Planning Commission Staff Report

Consideration of a request for approval of the Preliminary Plat for the Bentley Brook Subdivision Plat A, consisting of 6 lots located at 800 West Maple Street in the RA-1 Zone.

MAPLETON CITY DEVELOPMENT REVIEW COMMITTEE MINUTES

On September 25, 2018 Matt Baker submitted revised plans for the Bentley Brook Subdivision in the RA-1 zone and located at approximately 850 West Maple Street. The items below include 1) requested changes to the submitted plans, 2) other items required as part of the application and/or 3) informational items regarding city standards. **All items that include an * and are bolded are required prior to any public hearings.**

Plat " A "

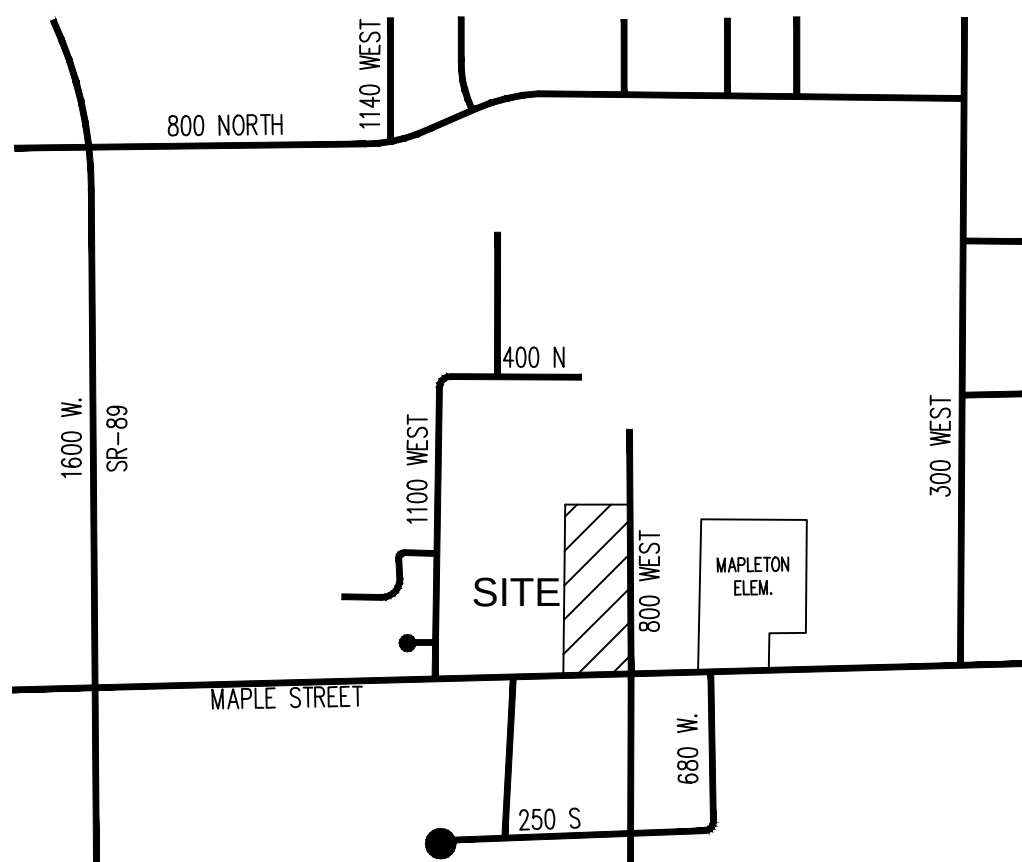
2. **A revised assigned address list is attached to these comments. Please label the lots accordingly.** Because the lots changed quite significantly since the last submittal, the addresses assigned have changed as well. I appreciate the attempt to assign addresses but the addresses you assigned work poorly with the assigned addresses in the proposed subdivision across the street (smaller numbers on lots located north of lots in the adjacent subdivision, etc.).

3. A gap exists between the subject parcel and parcels owned by Donald Bluth and Lamarr Nielsen near the north-eastern portion of the subject parcel.
4. **The Boundary Description does not match the calls on the graphic representation of the plat.** At least one of the calls that is given does not match the boundary description.

SITE/UTILITY PLAN

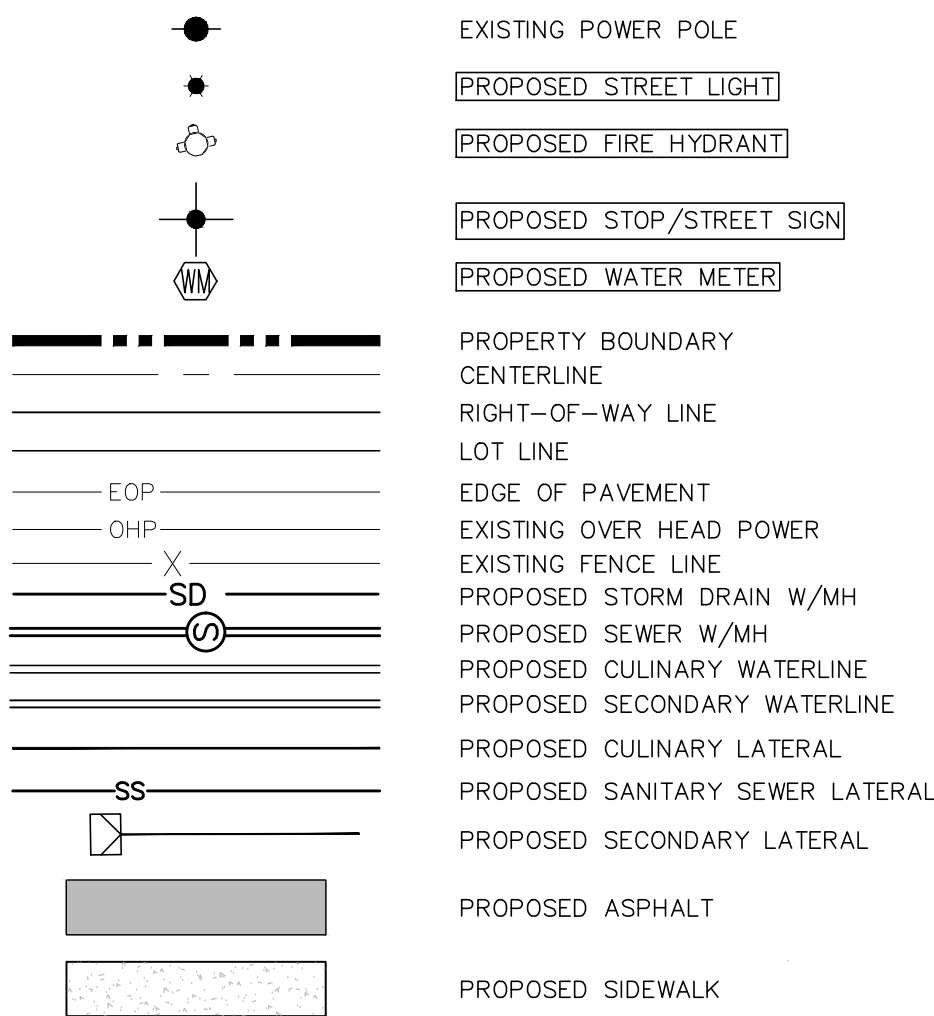
1. Please fix street labeling discrepancies, (PP-1).
2. Please show utilities in Maple Street including future PI main (PP-1).
3. Please label clearly on both the plan and profile view, all utilities that are either already existing or will be constructed as part of the Bluth subdivision.
4. Please add a streetlight at the south west corner of 800 West and Maple Street.
5. Pressurized Irrigation main line must be a minimum 8".
6. Sewer line must be SDR-35.
7. Install double PI lateral between lots 5&6 and 7&8 (UP-01)

8. If construction is not coordinated with adjacent development, an overlay will be required on the entire roadway up to the street centerline.
9. Please include a street cross section for all streets.
10. Please check the crown on 800 West at the intersection of Maple Street. Any crowning of the road should be parallel to the direction of travel on Maple Street. (PP-1)
11. Vertical curves are required on streets where the algebraic grade change exceeds 1%. (PP-4)
12. A cross gutter will be required on 800 W and 300 N. (PP-3)
13. Please show utility connections to lot 6. (UP-01)
14. Please add a stop sign at Maple Street. (UP-01)
15. 3 Valve clusters are required at all T connections.
